Barangaroo South
Stage 1B Public Domain
Independent Planning Commission Meeting

14 August 2018

Ground Plane Materials

Hickson Park Staging

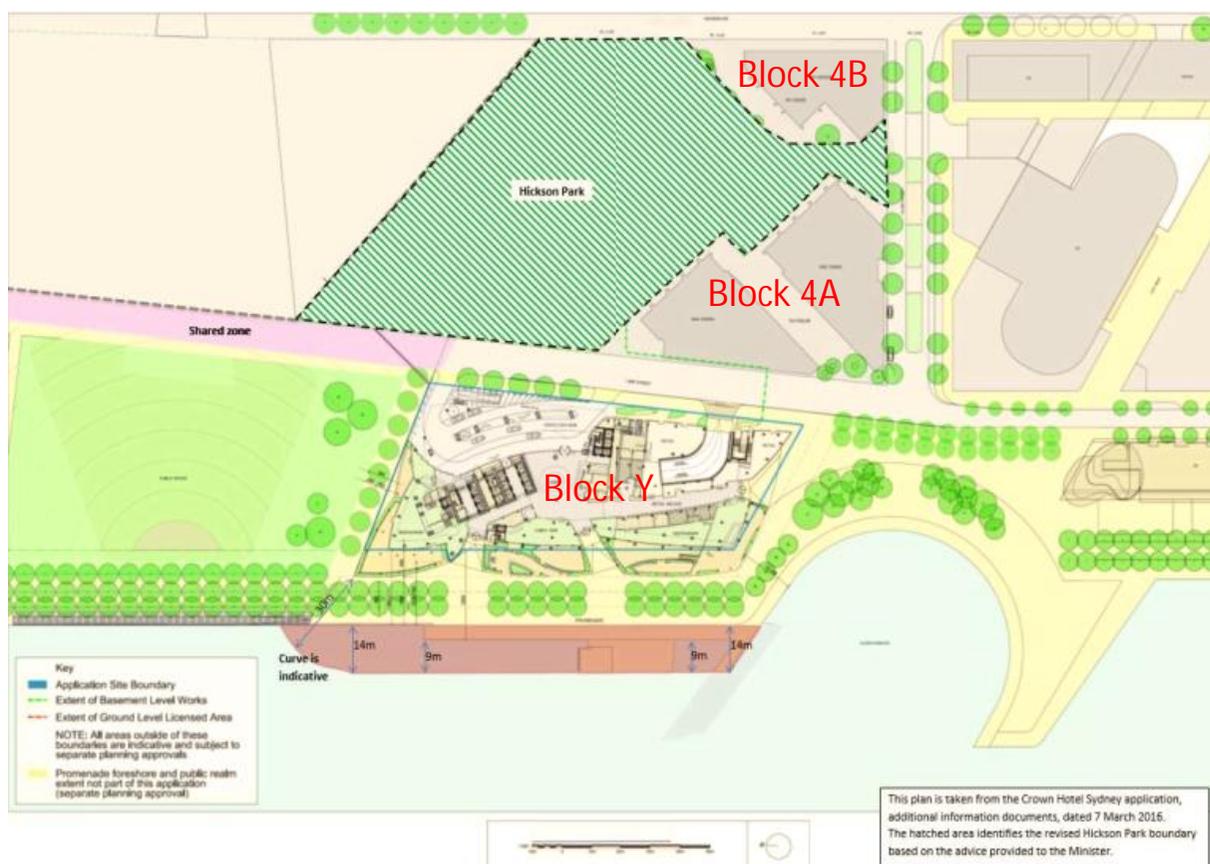
- Residential Towers will not be complete at the time of Crown's completion and opening.
- Construction exclusion zones are required to provide separation from the towers for both public safety and construction logistics.
- Staged completion of Hickson Park avoids inefficient and unnecessary re-work.

(XX) Hickson Park may be constructed and occupied in stages to provide for temporary exclusion zones required for the construction of residential buildings R4A, R4B and R5 . The area of Hickson Park and public domain adjacent to each building must be completed prior to the issue of the final Occupation Certificate for each respective building and prior to the issue of the final Occupation Certificate for the public domain.

Hickson Park Staging – Tower Exclusion Zones

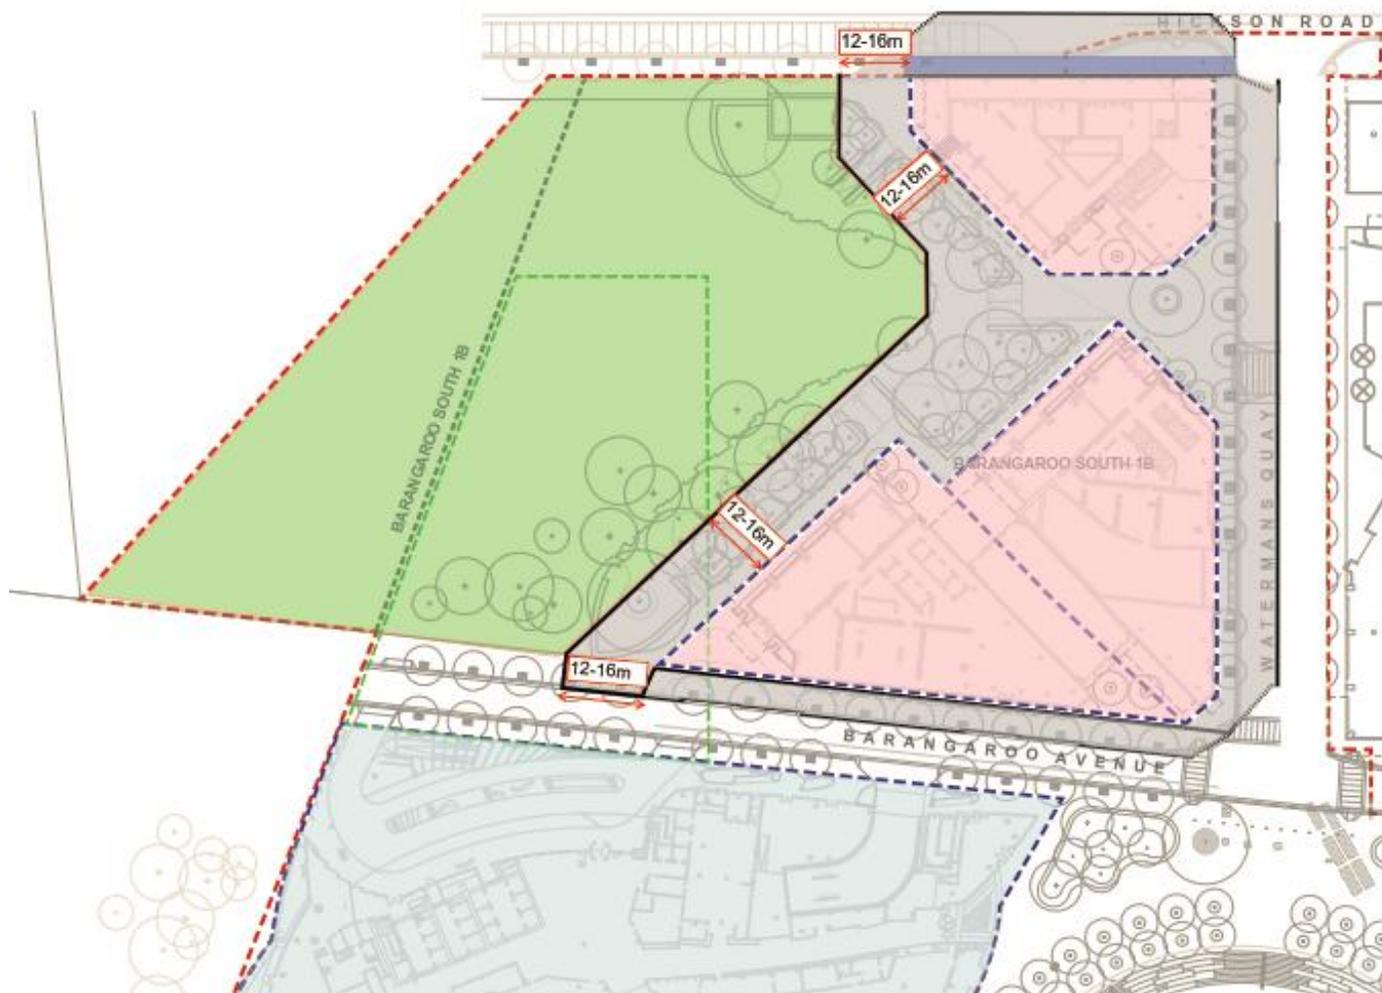
- Proposed staged delivery of Hickson Park allows for:
 - Delivery of 85% (17,827sqm) of total public domain
 - 100% of the Foreshore Promenade, Public Pier and Watermans Cove for the opening of Crown

CofS - Deep Soil Zone

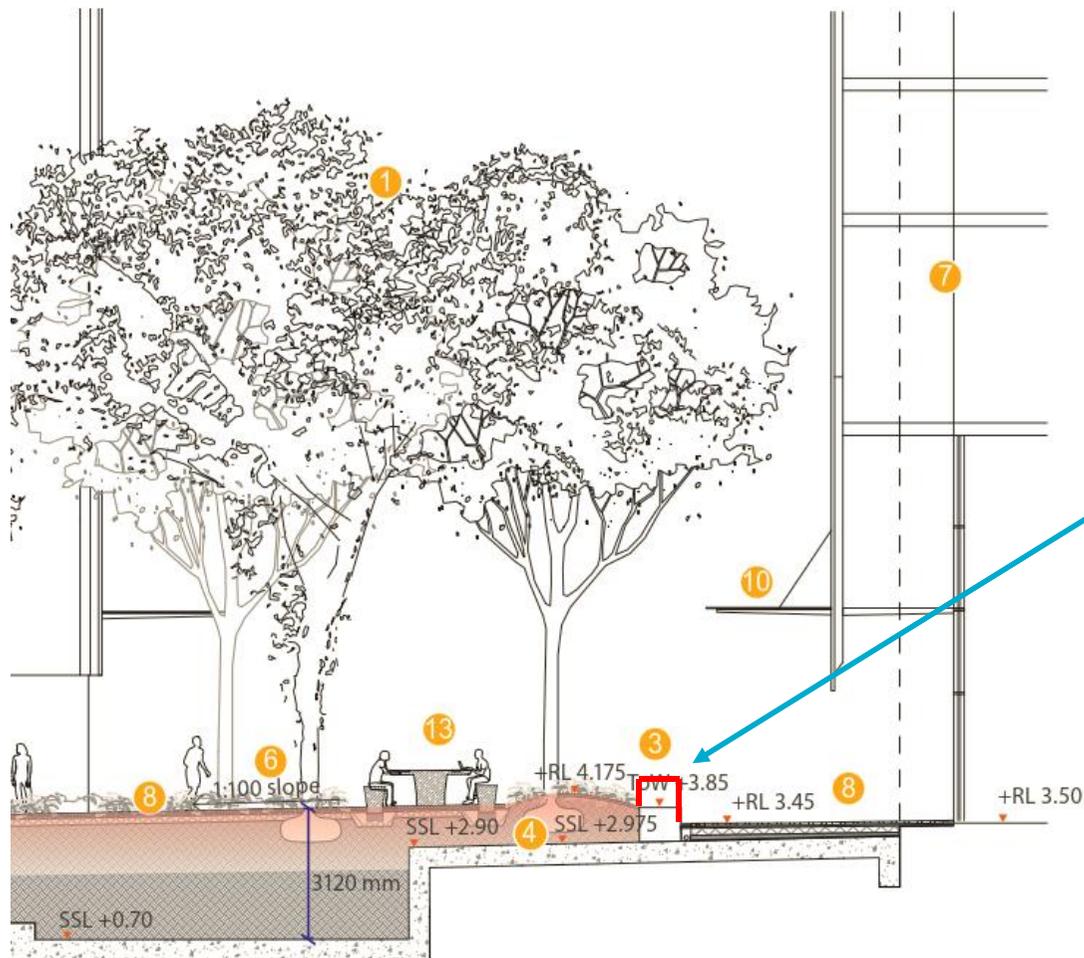
- City of Sydney proposal to avoid mounding of soil in planted areas:
 - Increased height of wall to RL 4.25
 - Utility of wall as seating is diminished
 - Need for balustrades at Hickson Road
 - Excessive height and bulk at main pedestrian entries

- 800mm high at worst case and 600mm high at best case.
- Poor height for casual seating

CofS - Deep Soil Zone

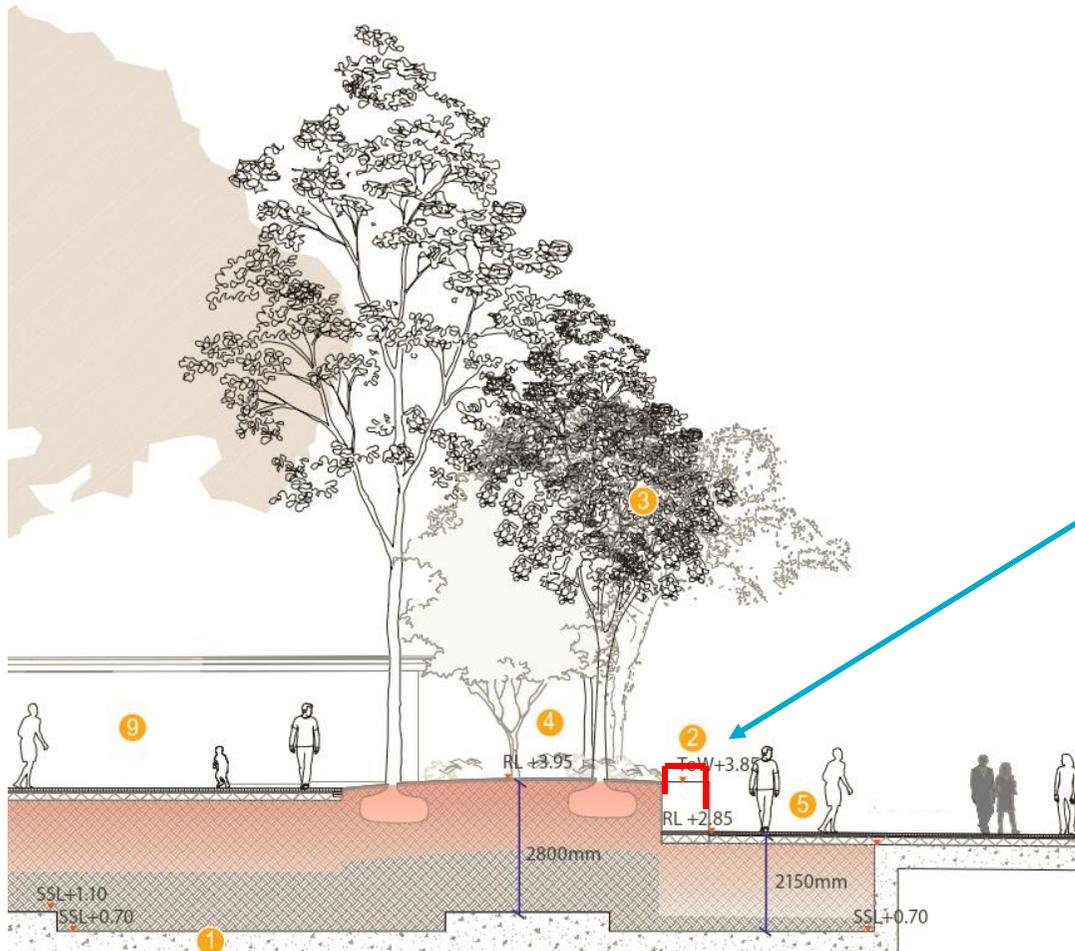
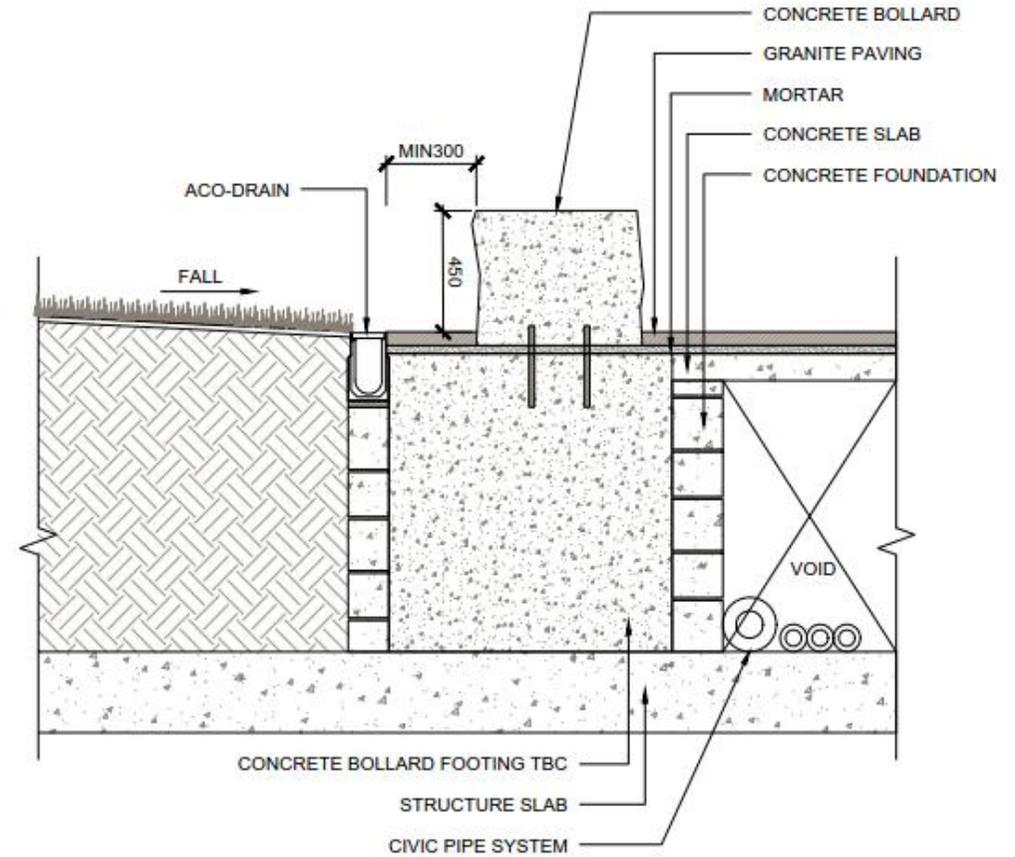
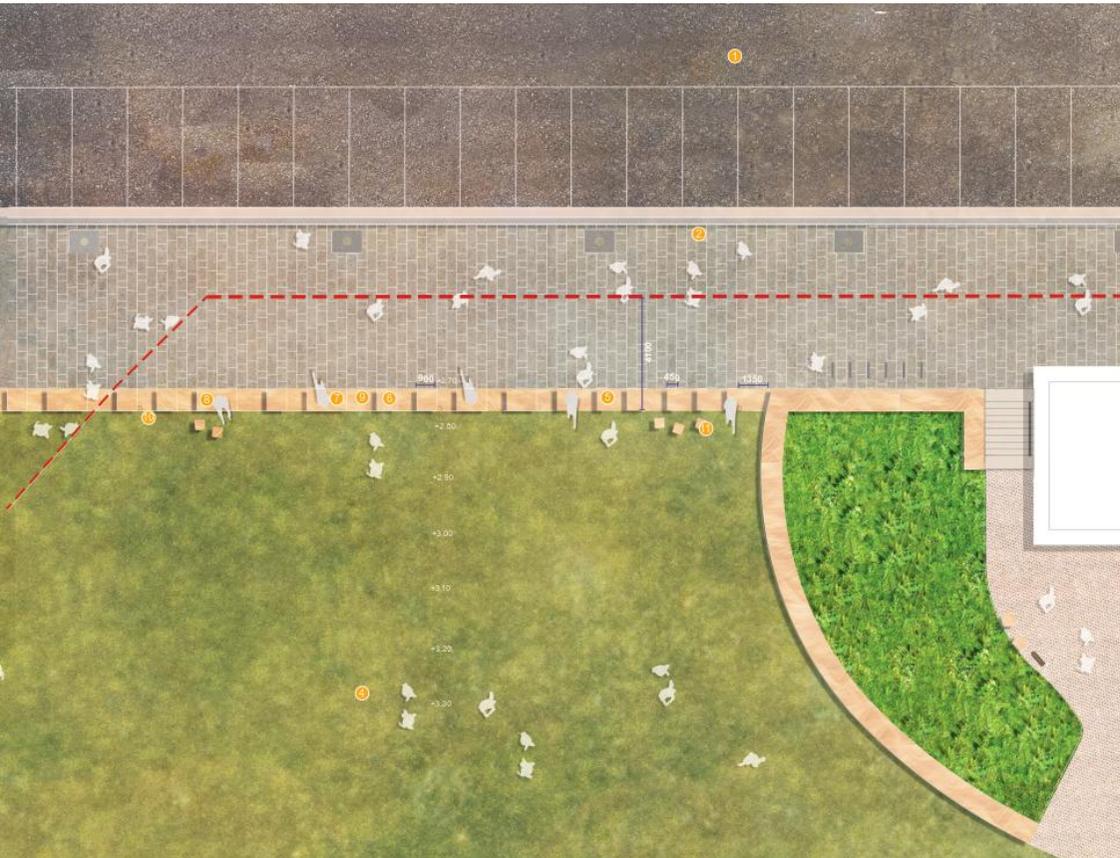
- City of Sydney proposal to avoid mounding of soil in planted areas:
 - Increased height of wall to RL 4.25
 - Utility of wall as seating is diminished
 - Need for balustrades at Hickson Road
 - Excessive height and bulk at main pedestrian entries

- 1,350mm high.
- > 900mm creates need for balustrade
